Access Compliance Report

Public Rights-of-Way

(Curb Ramps)

Intersection ID: 53635	Main Street: NEWBURY GROVE ST	Cross Street: TREMONT RIDGE CT	Location: NE
ADA ID: 390C91578492	Ramp Type: PerpDiag	Initial Pass/Fail: Fail	Overall Compliance: No
Severity Score: 37.5			
Codes/Mitigation Info/Possible Solution		Field Measurements/Component Compliance

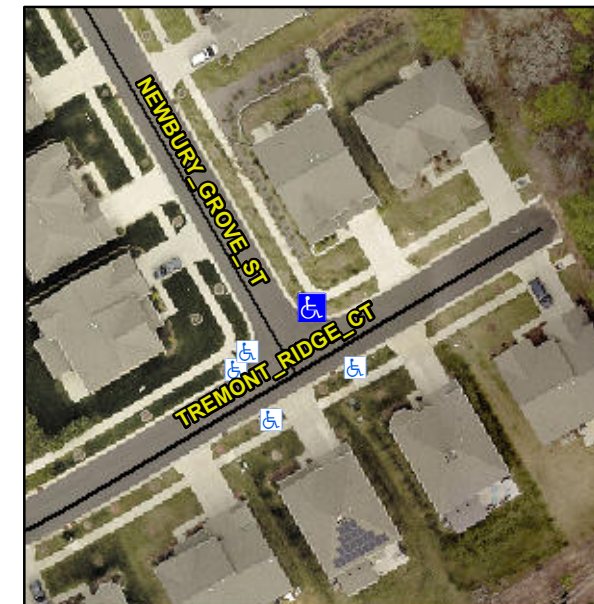
Not Found, R304.2.2, R304.5.3

Compliance	Description	Data	Compliance	Description	Data
N/A	Ramp Length (in)	96.0	No	Ramp Slope (%)	9.1
Yes	Ramp Width (in)	48.0	No	Ramp XSlope (%)	9.6
N/A	Flare Type LT	N/A	N/A	Flare Type RT	N/A
N/A	Flare Slope LT (%)	N/A	N/A	Flare Slope RT (%)	N/A
N/A	Flare Traversable LT?	N/A	N/A	Flare Traversable RT?	N/A
N/A	Landing Length (in)	N/A	N/A	DWS Provided?	N/A
N/A	Landing Width (in)	N/A	N/A	DWS Contrast?	N/A
N/A	Landing Slope (%)	N/A	N/A	DWS Length (in)	N/A
N/A	Landing X Slope (%)	N/A	N/A	DWS Full Width?	N/A
N/A	Landing Curb? (Y/N)	N/A	N/A	DWS Offset (in)	N/A
N/A	Shared Landing?	N/A			
N/A	Gutter Ponding?	N/A	N/A	Gutter Slope (%)	N/A
N/A	Gutter Lip Ht (in)	1.5	N/A	Gutter X Slope (%)	N/A
N/A	Painted X Walk1?	No	N/A	Painted X Walk2?	No
	X Walk 1 Direction	To SW		X Walk 2 Direction	To SE
N/A	X Walk 1 Width (in)	N/A	N/A	X Walk 2 Width (in)	N/A
	X Walk 1 Slope (%)	1.5		X Walk 2 Slope (%)	7.2
	X Walk 1 X Slope (%)	5.5		X Walk 2 X Slope (%)	7.5

N/A	Ramp inside XWalk1?	N/A	N/A	Ramp inside XWalk2?	N/A
	Road Slope (%)	7.3	N/A	Clear Space?	N/A
	Road X Slope (%)	2.8	N/A	Clear Space to XWalk (in)	N/A
N/A	Any Obstructions?	N/A	N/A	Storm Grate/Utility Hazard?	N/A
	Obstruction Type			Storm Grate/Utility Type	
		N/A			N/A
		Yes		Surface Condition? (G/P)	Good

Remove & Replace Curb Ramp With Two New Directional Ramps or Equivalent.
